Proposal for amendments to ECE/TRANS/WP.29/GRBP/2020/13

The changes compared to document ECE/TRANS/WP.29/GRBP/2020/13 are marked in red.

"Uniform provisions concerning the approval of pneumatic tyres for commercial vehicles and their trailers"

Annex 3, Figure, replace and amend to read:

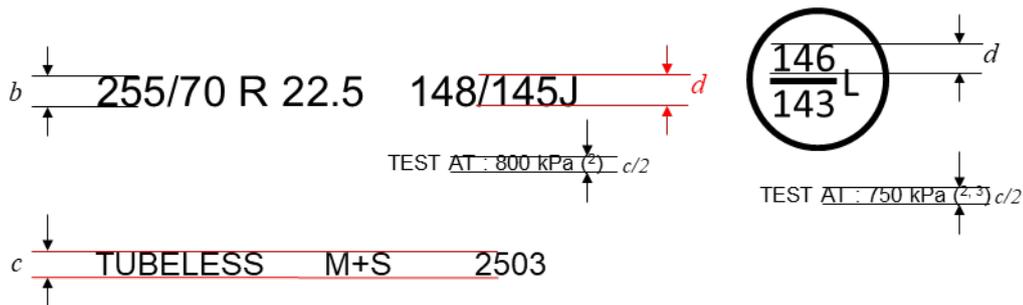
"Example 1:

(1) PSI marking instead of kPa is allowed for tyres first type approved before 1 January 2018. The kPa marking may be preceded by "TEST AT : " or, alternatively, by "TEST INFL : " or the symbol "@".

Example 2:

- (2) "TEST AT : " may be replaced by "TEST INFL : " or the symbol "@" or be omitted.
- (3) The indication of a second inflation pressure for the additional service description is optional. If there is no indication, the same test inflation applies to both load/speed combinations.

(4) For "ML" and "MPT" being part of the tyre size designation marking the minimum dimension *b* applies."

Requiring to be inflated to ~~620~~800 kPa for both load/speed endurance tests in Example 1 and 800 kPa for the load/speed endurance test according to the main load/speed combination and 750 kPa for the test according to the additional load/speed combination in Example 2 for which the PSI symbol is 90."

“(e) If there are two indications for the test inflation pressure, they must be placed in such a way that it is clear which pressure indication belongs to which load/speed combination.”
